BRISTOL SUBDIVISION, FIRST ADDITION AND ADDITION

APPLICATION NUMBER 2 DATE December 20, 2007

BRISTOL SUBDIVISION, FIRST ADDITION AND ADDITION

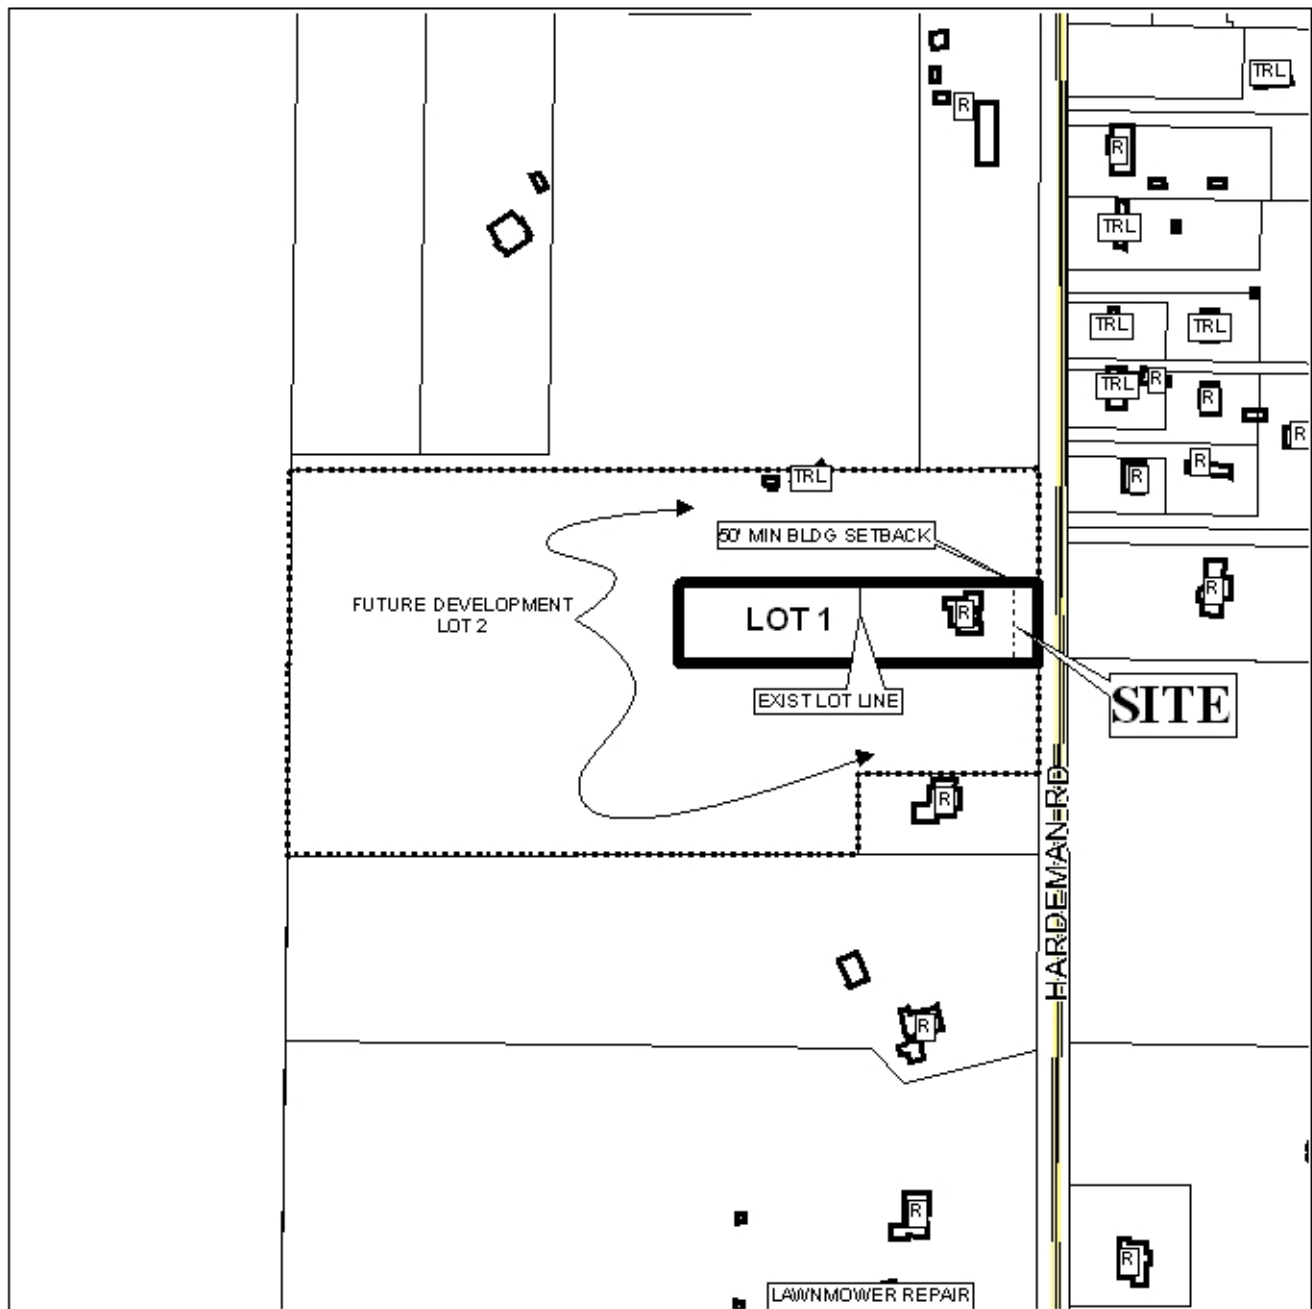
This application was held over at the November 15th meeting to allow the applicant to submit a revised plat designating the remainder of the parent parcel as Lot 2 OR future development. The applicant submitted a revised plat designating the remainder of the parent parcel as future development AND Lot 2. The plat should be revised to label the remainder of the parent parcel as future development only.

The approval of Bristol Subdivision First Addition, recorded in 2002, required the provision of a 50' setback (including the minimum 25' building setback) from the centerline of Hardeman Road. The applicant simply wishes to expand this recorded lot. The number of lots is not being increased. Therefore, the original setback condition would be appropriate. However, the original condition was confusing. Since Hardeman Road is a Planned Major Street, it requires 50' of right-of-way from its centerline. The minimum building setback line should be measured from this right-of-way. Therefore, it is recommended that the plat be revised to provide a 75' setback (including the required 25' building setback) from the centerline of Hardeman Road.

As proposed, Lot 1 exceeds the minimum width to depth ratio required by the Subdivision Regulations. However, there are several legal lots directly across Hardeman Road that exceed the minimum width to depth ratio. Therefore, a waiver of Section V.D.3. of the Subdivision Regulations would be appropriate.

The plat meets the minimum size requirement for developments with access to public water and septic systems. However, it is requested that the applicant revise the preliminary plat to label the lot with its size in square feet, or provide a table on the plat with the same information.

- 1) provision of a 75' setback (which includes the required minimum building setback of 25 feet) from the centerline of Hardeman Road;*
- 2) revision of the plat to label the remainder of the parent parcel as future development only, **NOT** Lot 2;*
- 3) labeling of the lot with its size in square feet, or the provision of a table on the plat with the same information;*
- 4) placement of a note on the final plat stating any lots developed commercially and adjoin residentially developed property must provide a buffer, in compliance with Section V.A.7. of the Subdivision Regulations; and*
- 5) submission of a letter from a licensed engineer certifying compliance with the City's stormwater and flood control ordinances should be submitted to the Mobile County Engineering Department and the Planning Section of Urban Development prior to the issuance of permits.*
